Finding identification & remedial schedule - 8 October 2026

Project	Riverside Court - Cat B Fit-Out, Phase 2
Client	Halloway Cross Estates Ltd
Address	Riverside Court, 42 Kelham Street, Sheffield S3 8LP
Reference	SNG-2026-10-006
Report date	8 October 2026
Status	Draft - not yet published
Items included	20

Photograph 8 - 3 items on this photograph, 3 pins on this photograph

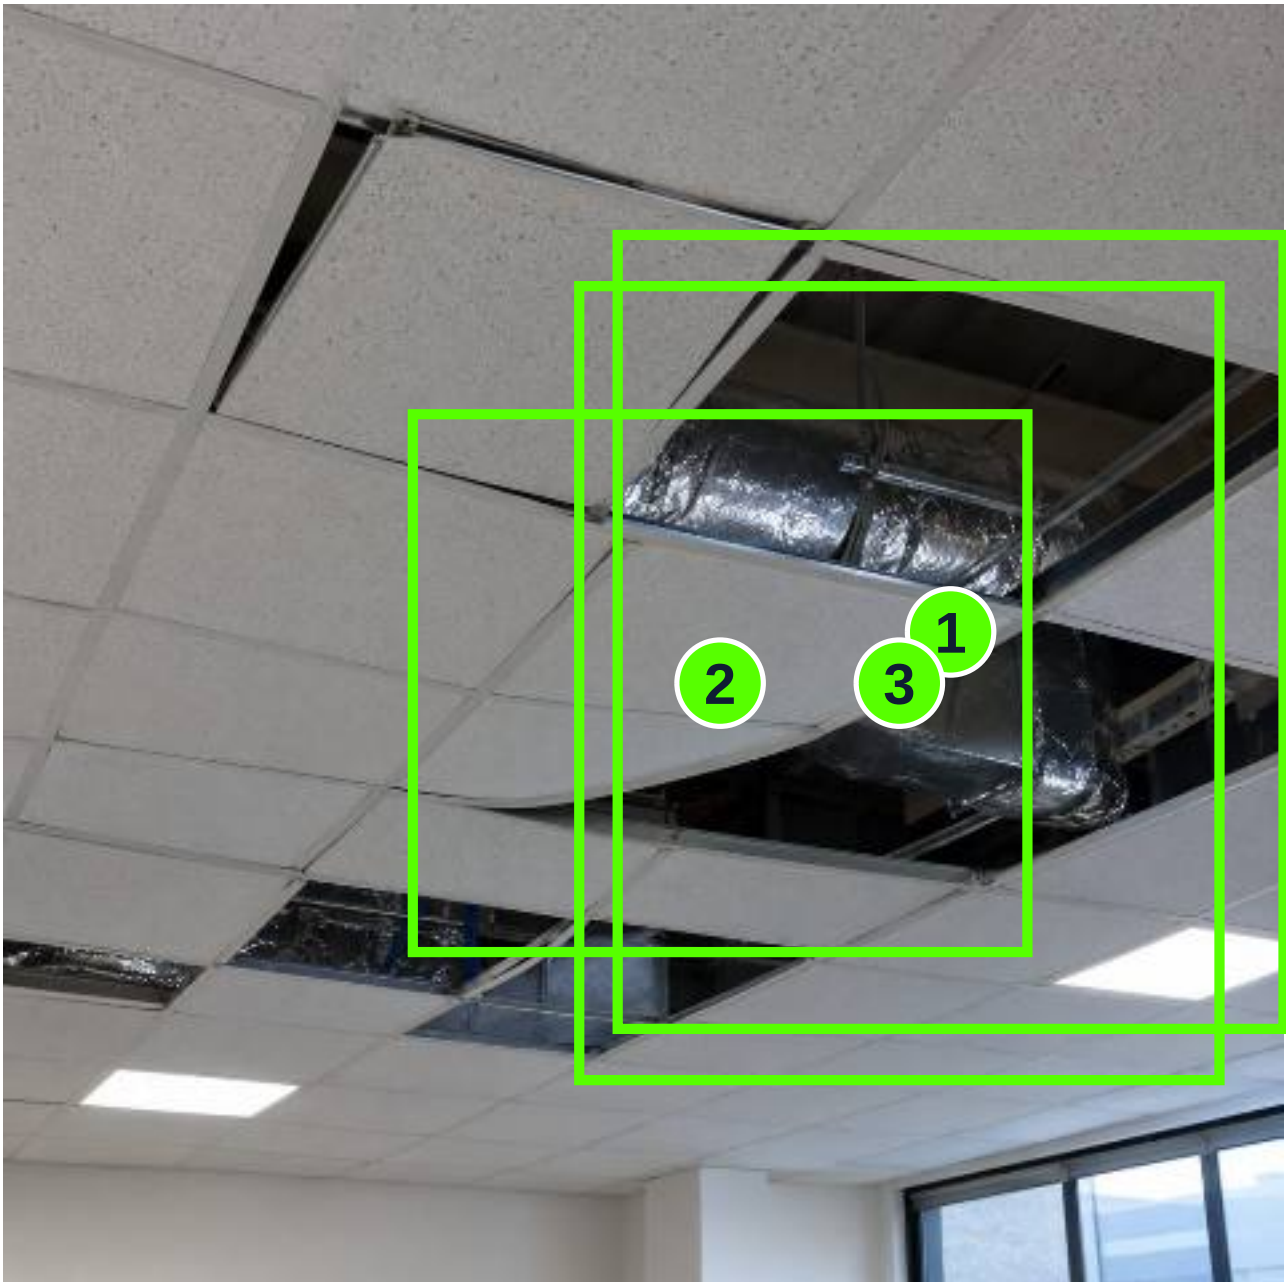
Pin 1 - Item 7 - Four ceiling tiles are absent from the suspended grid, exposing the ceiling void.

Pin 2 - Item 8 - Pieces of ceiling tile are sagging below the underside of the grid, one adjacent to the open void at the centre of th...

Pin 3 - Item 9 - Within the open void, a length of insulated ventilation duct wrapped in foil-faced insulation is visible.

Four ceiling tiles are absent from the suspended grid, exposing the ceiling void. The surrounding tile edges remain in place within the grid. It cannot be determined from the photograph whether the tiles have been removed for access to the services above or whether they are missing as a defect, and the exclusion for work in progress applies until that is confirmed.

Within the open void, a length of insulated ventilation duct wrapped in foil-faced insulation is visible. The insulation is creased and reflective where it passes over the grid line at the upper left of the opening. No duct appears to be supported directly off the ceiling grid in the area shown. The visible surfaces appear dry and intact. Duct installation is commonly left incomplete at the time of the photograph, and this cannot be resolved from a single image.

Establish on site whether the tiles have been removed for maintenance access. If they have, they are to be replaced on completion of the works; if not, replacement tiles to be sourced to match the existing pattern and installed. No fix should be specified until the reason for removal is known.

Before handover, verify the duct support spacing and the continuity of the vapour-tight insulation against the duct manufacturer's installation instructions and the project specification. Where the insulation has been disturbed or gapped at the grid line, re-dress and tape the joints to restore the vapour seal.

Pin 2 of 2 - photograph 9
A crop of the area this item refers to.

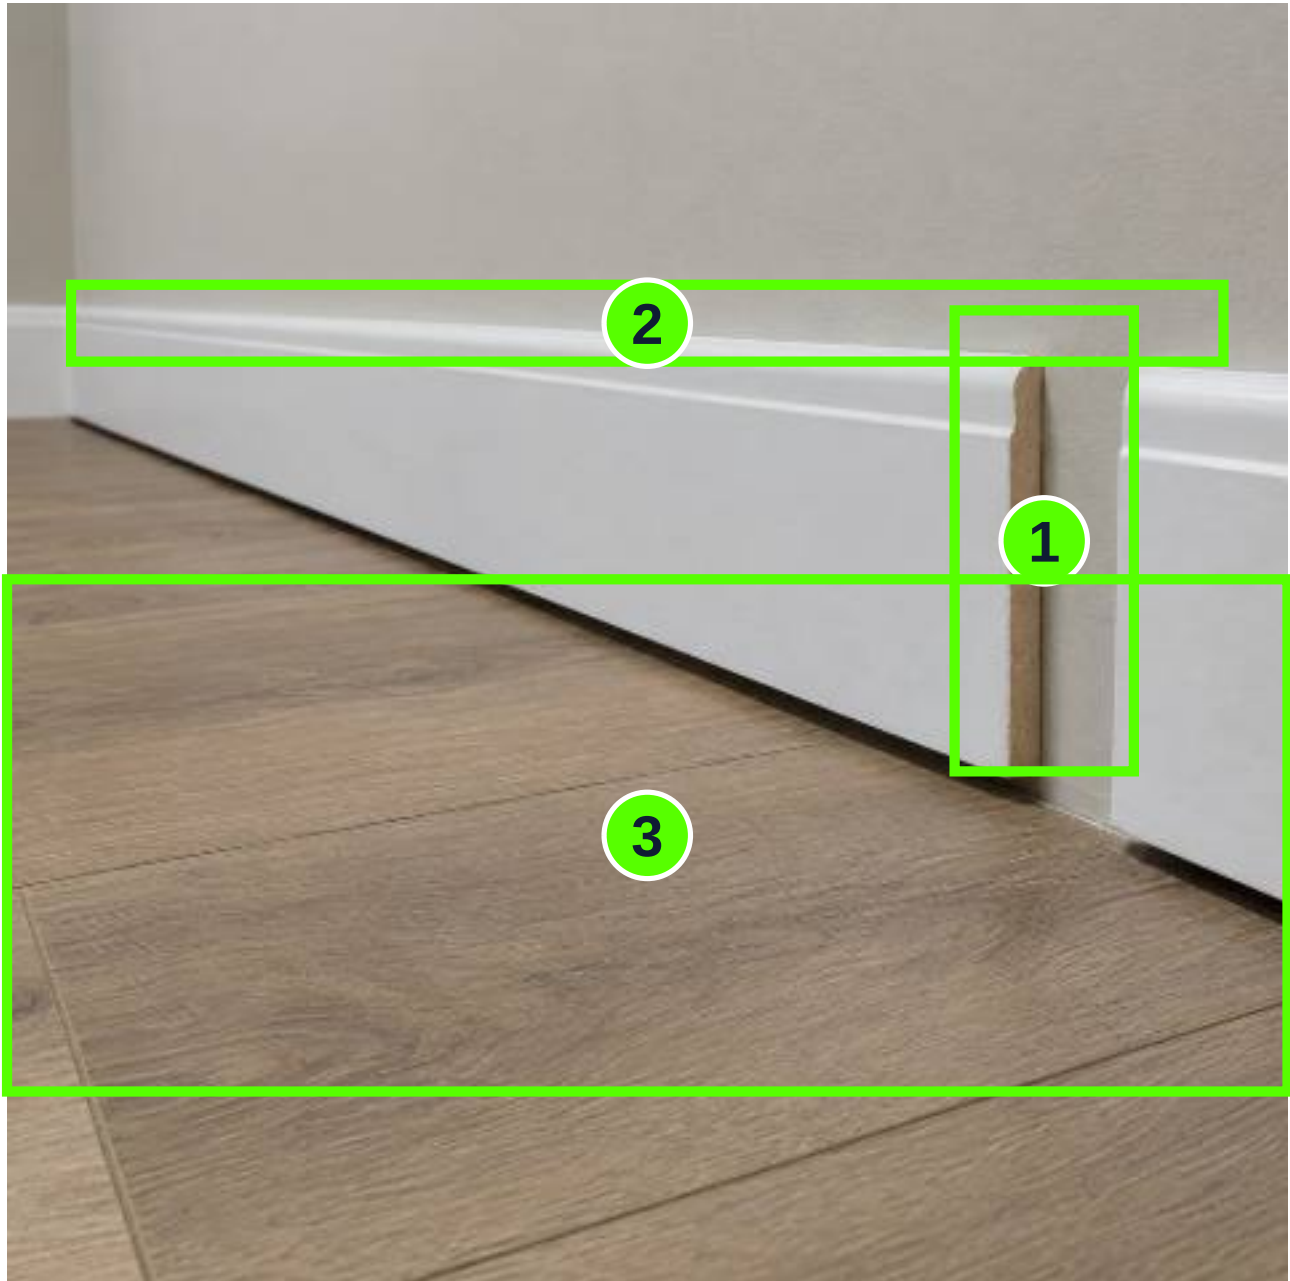
At the threshold opening, the junction between the concrete floor slab and the base of the blockwork wall and the door frame is broken down, with loose aggregate, mortar and debris present in the gap. The frame sits on a small mortar or screed bed which is crumbly and uneven, and there is a visible gap between the underside of the frame and the slab. The extent of the gap and whether a weather seal or damp-proof detail is present cannot be confirmed from this image.

Likely cause: Most likely the bedding or pointing at the threshold has broken down through impact from traffic or from the frame installation, or the base bed was laid on a dusty or unprepared slab and has debonded. It may also be that the junction has never been properly finished, and this is incomplete work still to be done.

Remove all loose mortar, aggregate and debris from the threshold junction and clean back to sound material. Confirm on site whether this is an external opening: if it is, the threshold must incorporate a continuous damp-proof course and a sealed weather detail in accordance with the manufacturer's instructions for the frame system. Re-point and make good the base bed to the frame, sealing the junction with a suitable external-grade sealant, and ensure the damp-proof course is lapped and continuous. Refer the detail to the principal contractor's design lead where the as-built junction does not match the specified detail.

Pin 2 of 3 - photograph 8

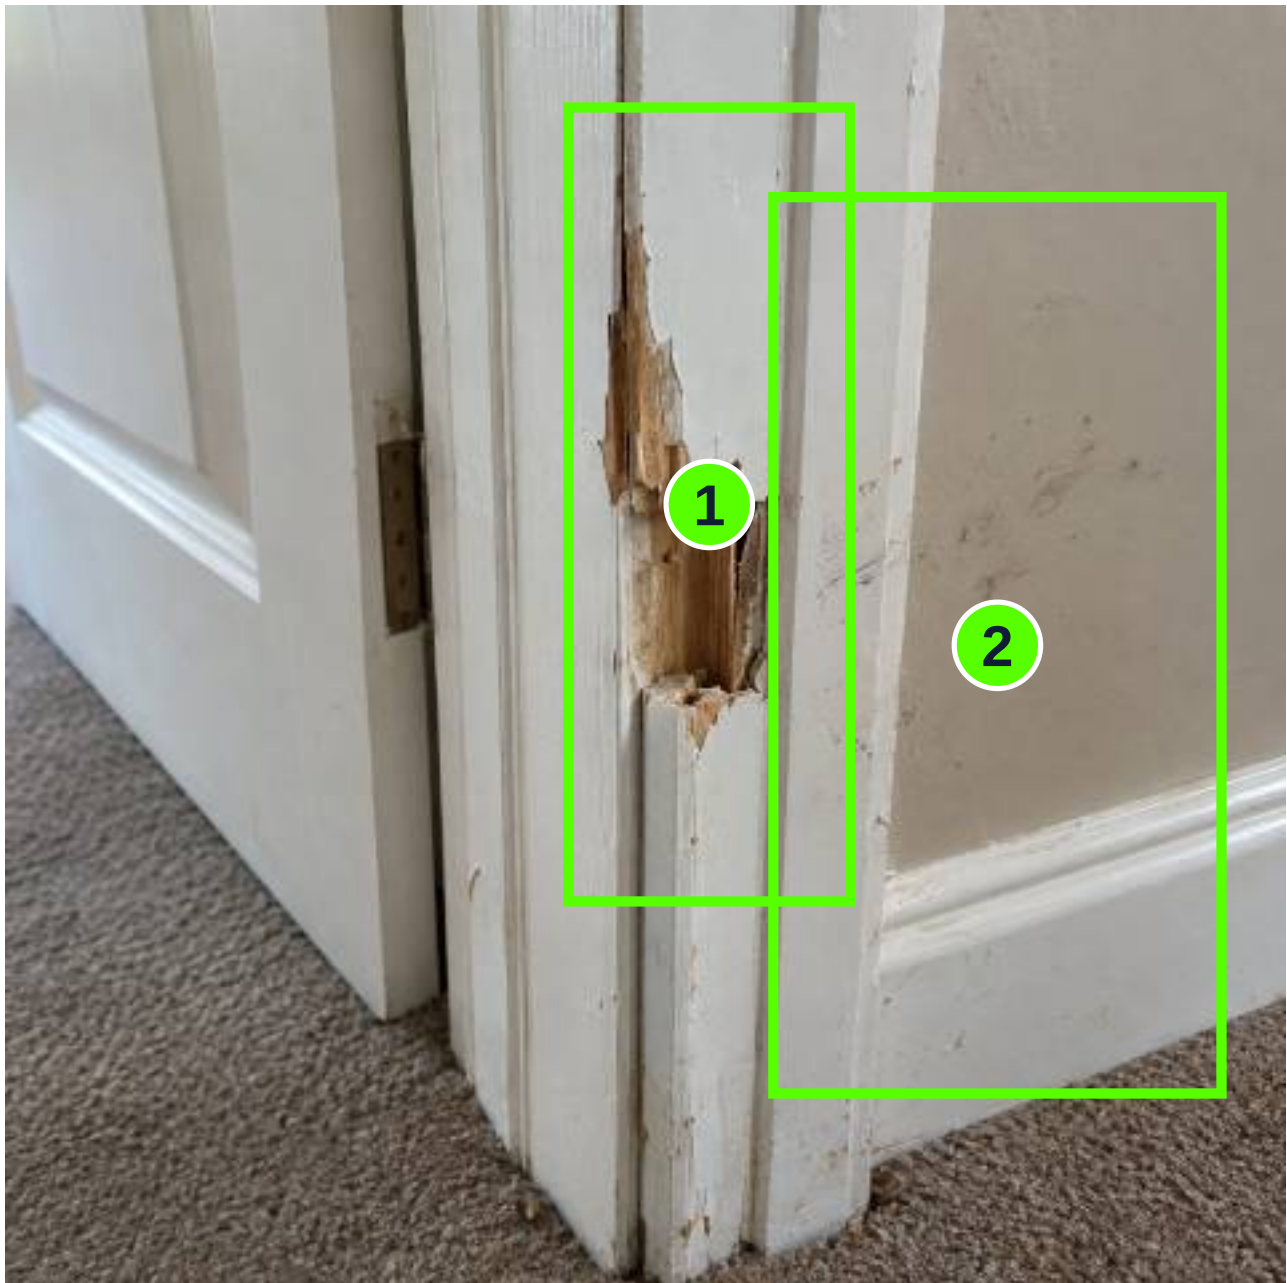
Pieces of ceiling tile are sagging below the underside of the grid, one adjacent to the open void at the centre of the image and a further two in the lower left of the frame. The tiles have lost flatness and are sitting proud of the grid line. No staining or water marking is evident on the affected tiles from this view.

Likely cause: Moisture uptake, overloading or physical distortion during handling and installation are all plausible. A single photograph does not allow the cause to be established.

Lift and reseal the affected tiles onto the grid flanges. If the sagging recurs or the tiles will not sit flat, remove one tile and inspect the void for moisture, damaged grid sections or overloading. Replace any tile that remains deformed.

Pin 1 of 3 - photograph 2

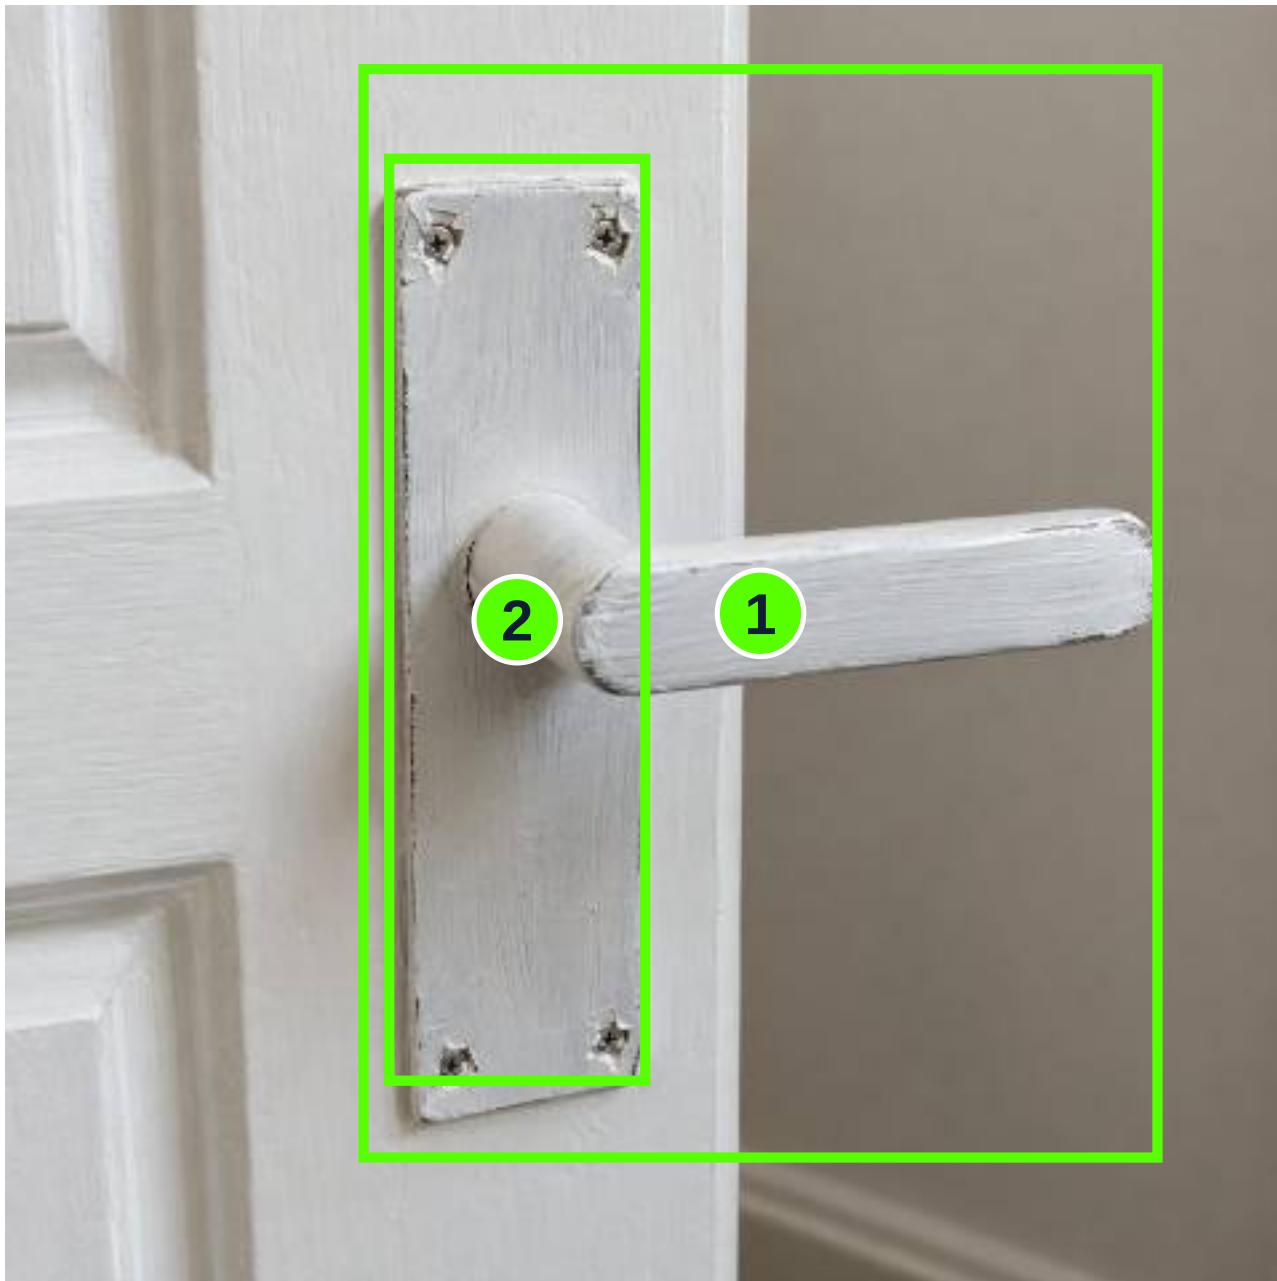
The silicone sealant at the junction between the rear upstand of the white ceramic basin and the tiled wall has been applied poorly and smeared across the tile face and the basin surfaces. The sealant line is irregular in width, feathered against the glaze, and spread in patches over an area roughly 250 mm wide and 120 mm high around the tap. Tooling is absent: the bead is left as a series of smears rather than a continuous fillet.

Likely cause: The most likely cause is application of the sealant without tooling or masking, applied by an operative not experienced in sanitaryware sealing. An alternative or contributory cause is a re-seal carried out over an inadequately cleaned and prepared joint.

Cut out and remove the existing silicone mechanically with a sealant remover or sharp blade, clean both faces with a suitable solvent to remove all residue and grease, allow to dry, then apply a single continuous bead of sanitary-grade silicone and tool it immediately to a consistent fillet. The tiler or sanitaryware installer owns this junction.

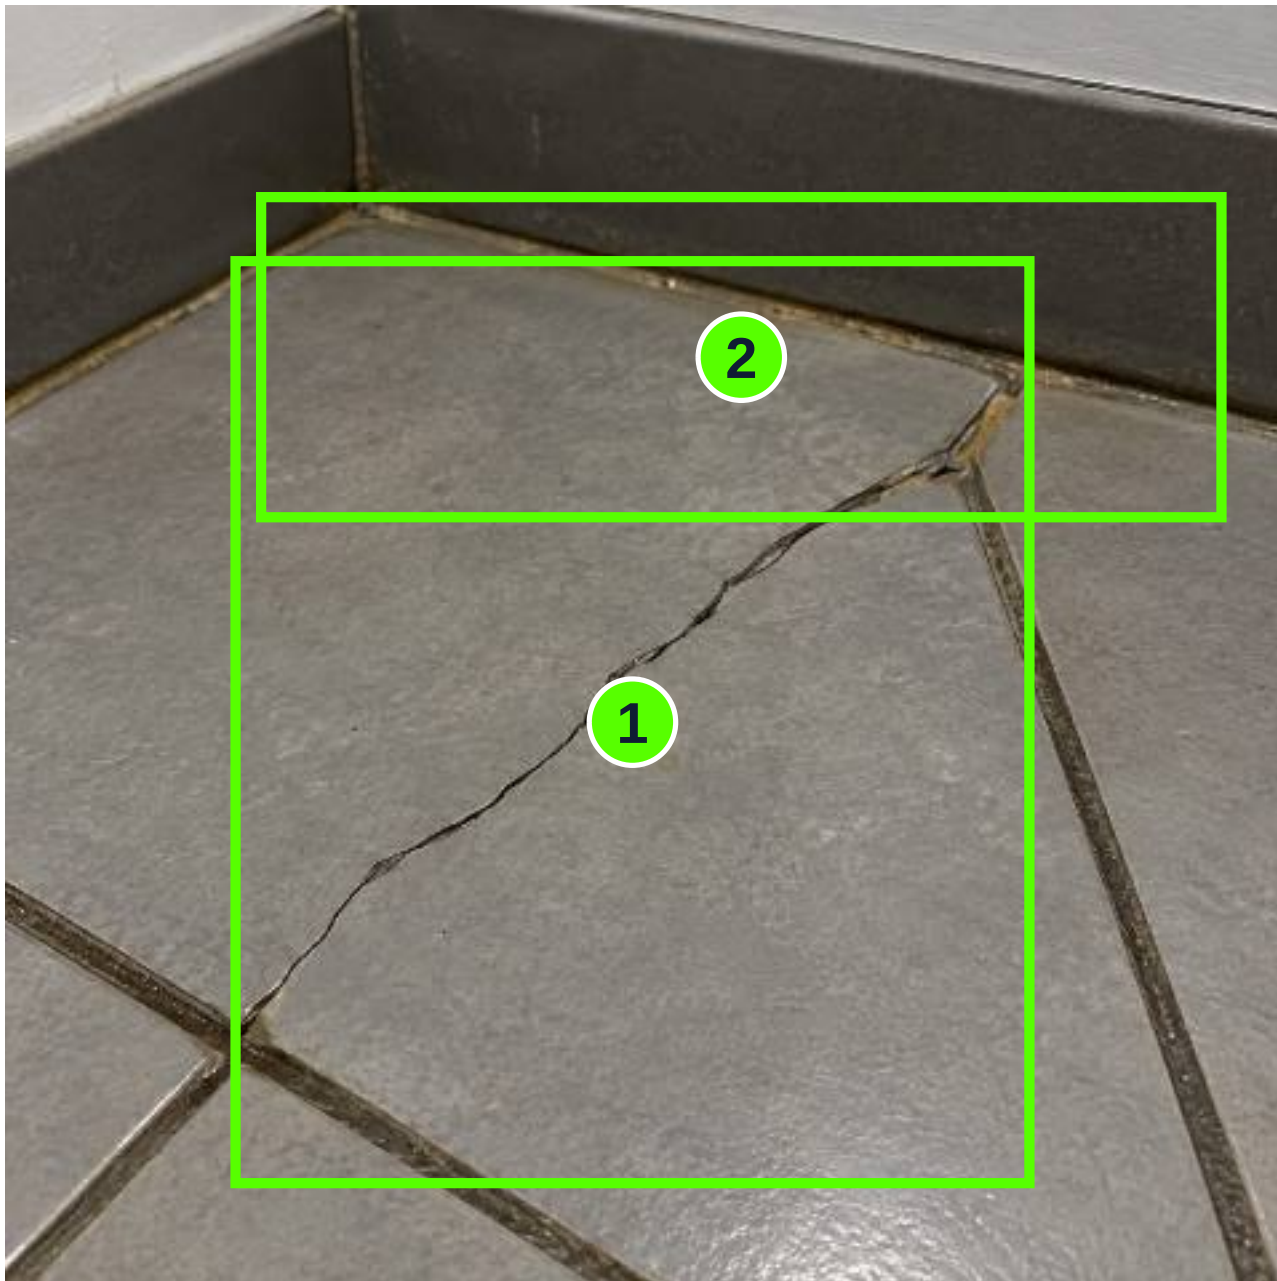
The external corner between the two plastered wall faces is damaged over a vertical run of approximately 200mm. A metal angle bead is exposed along the corner and the plaster skim has broken away from it in irregular flakes, leaving the grey backing coat and the bright metal bead visible. The damage is widest at the upper third of the exposed section, roughly 60mm across on the face to the right, and tapers to a crack below. The remaining plaster edges are proud and feather-edged, and the painted finish is fractured back from the break line.

Likely cause: Most likely impact damage to the corner arris after plastering, either from a trolley, board or other site movement, which has broken the skim away from the bead. A secondary possibility is that the bead was not adequately bedded or fixed, so the plaster never bonded to it and failed under minor contact. The photograph alone does not establish which, and both should be checked on site before the repair is specified.

Cut back the paint and loose plaster to sound, well-bonded material around the full extent of the damage. Check the angle bead is correctly fixed and does not move under finger pressure; refix or replace if it is loose, and confirm it is set plumb and true before making good. Pre-wet the edges, fill flush over the bead with a suitable patching plaster in two coats, allow to dry, then fill and sand the corner to a true arris. Spot prime and repaint the full corner to a natural break in the wall finish so the patch does not read. Carry out after the room is otherwise finished to avoid repeat damage.
